**Comments
for the
Draft Supplemental Environmental Impact Statement**

Thank you for your interest and comments regarding the Draft Supplemental Environmental Impact Statement (SEIS). All comments have been carefully read and incorporated into the Final SEIS document when possible. All letters, emails, and public hearing comments are included in this appendix. Reference is made to the spreadsheet which provides the list of individuals, agencies, stakeholders and neighborhood associations which have provided feedback to the Draft SEIS.

This is in response to your comments regarding "Technical Observations on June 12, 2012 Draft Environmental Impact Statement for Indianapolis North Flood Damage Reduction, Indianapolis, Indiana" dated September 28, 2012.

Photo 5: Corroded connections on 48" sluice gate & deteriorated headwall (Station 0+50)

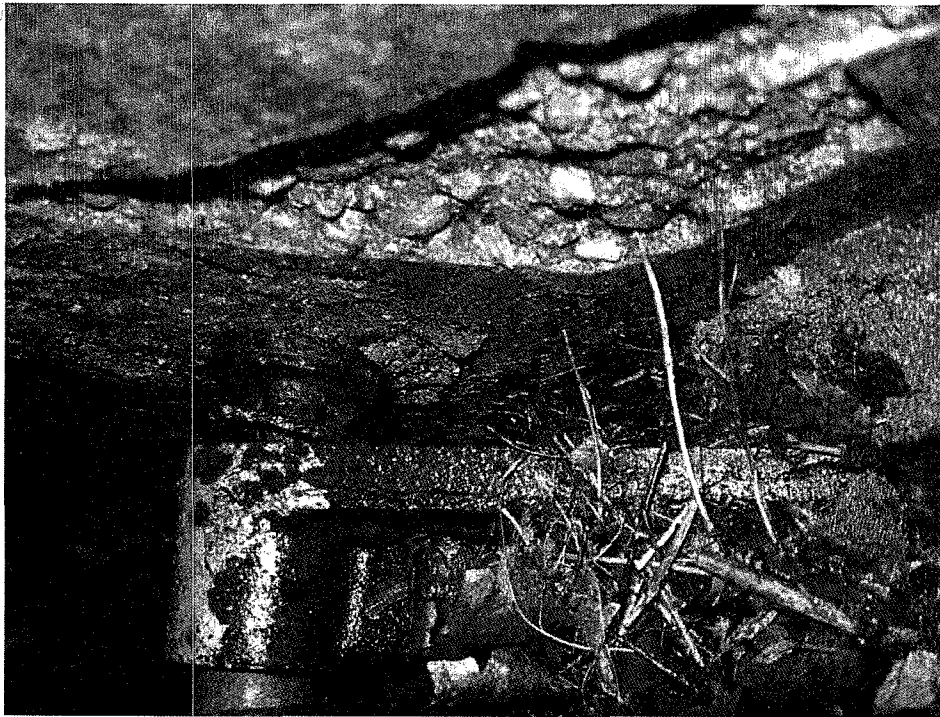
Photo 3: Concrete headwall and flap gate (Station 0+50)
Note the large crack at the top of the headwall.

Photo 4: 48" Sluice gate on landward side of levee (Station 0+50)
Note the corrosion on the gate and the large tree limb that has fallen on the guides.

Photo 10: Landward slope (Station 9+00)
Note the extensive tree growth and lack of grass cover.

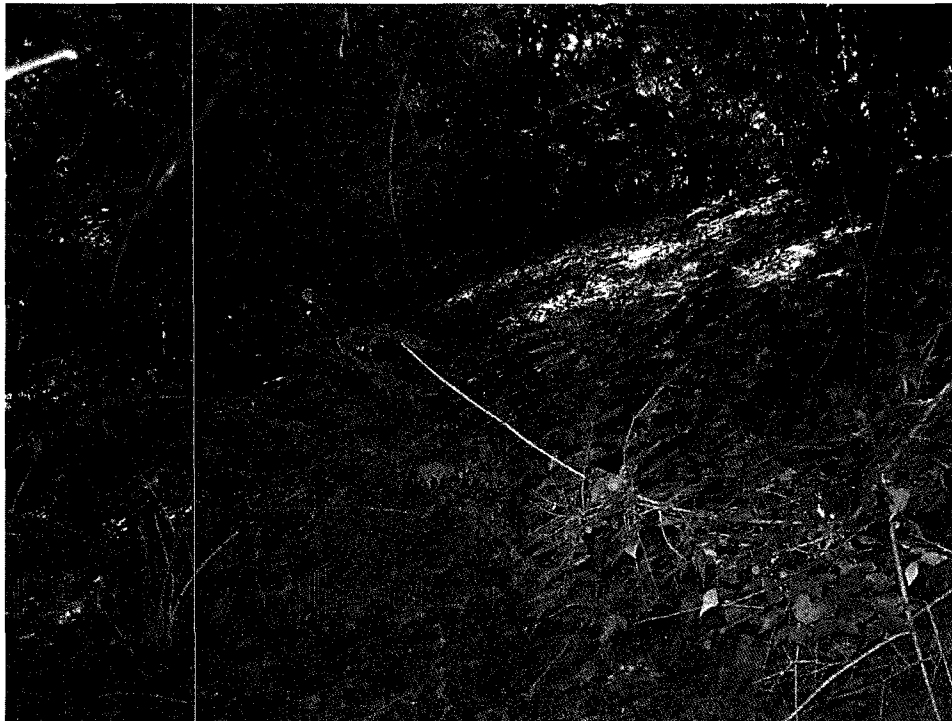
Photo 8: Large tree uprooted on levee embankment (Station 6+00)

Photo 9: 36" Interceptor sewer exposed near landward toe; crosses through levee (Station 7+90)

Photo 11: Riverward slope (Station 10+20)
Note the extensive tree growth and lack of grass cover.

Photo 20: Riverward slope of levee and crest looking north (Station 28+00)
Note the tree growth on the riverward slope and the houses encroaching onto the levee.

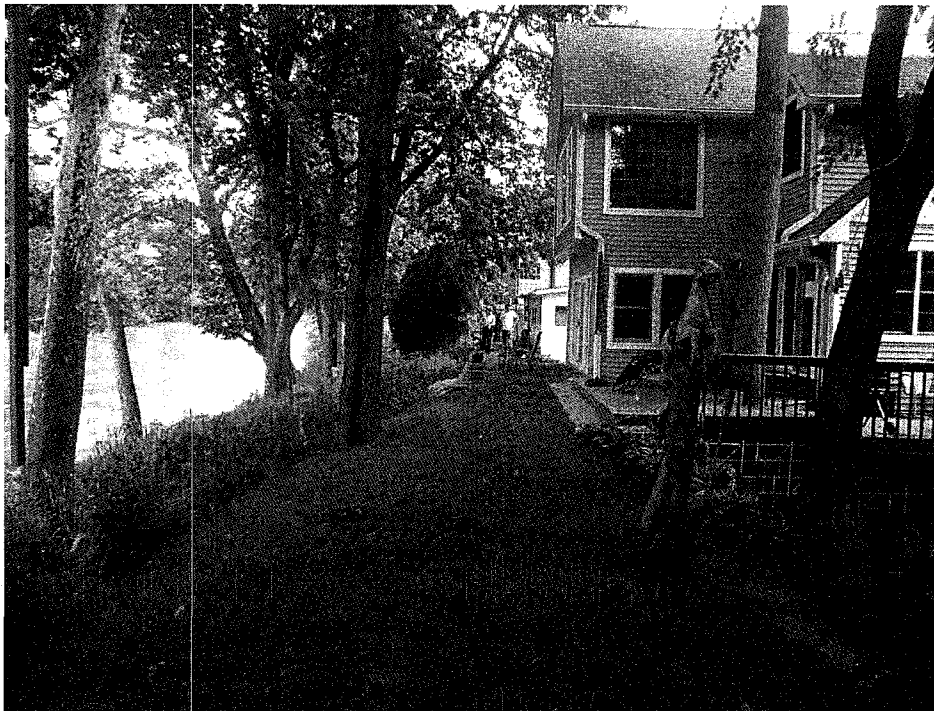
Photo 18: Riverward slope of levee looking south (Station 25+20)
Note the tree growth, undesirable vegetation, and encroachments.

Photo 19: Riverward slope of levee looking north (Station 27+00)
Note the tree growth and undesirable vegetation.
